Addendum No. 8

**RFP No. 23-02
Mental Health Ward Renovations at RC Jail**

April 26, 2023

PENAL USE VANDAL PROOF SHOWER DRAIN

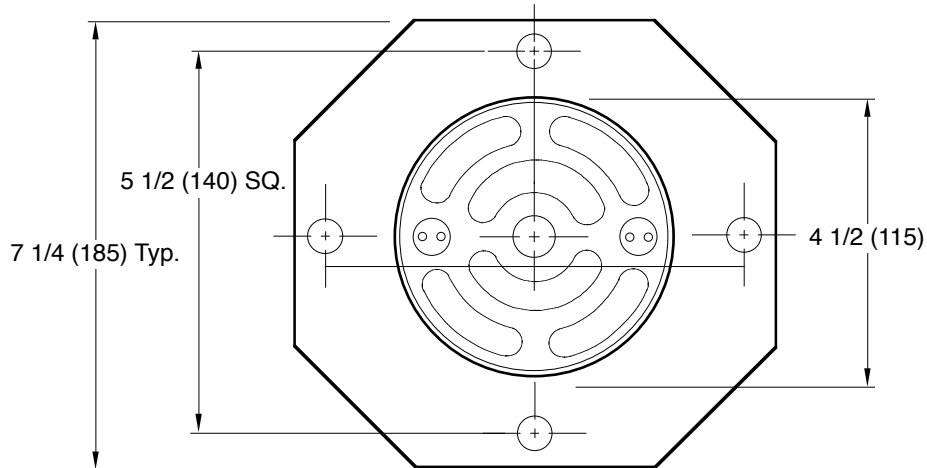
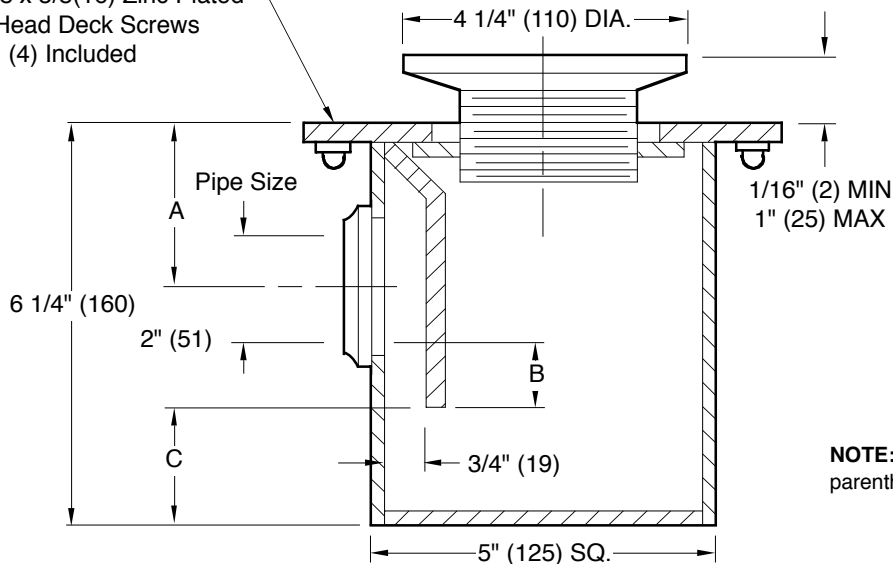
26. Question: General notes #7 on Sheet P-1.01 refers to replacement of shower fixtures, provide specifications & quantities?

27. Question: Key notes D-12 on Sheet P2.01 refers to replacement of shower drains, clarify type/quantity & does it refer to all FD-1 shown on drawings?

Answer: See attached. All existing shower fixtures and floor drains area to be replaced. Repair areas affected by the repairs with patching materials and refinish all of the areas as required by the documents.
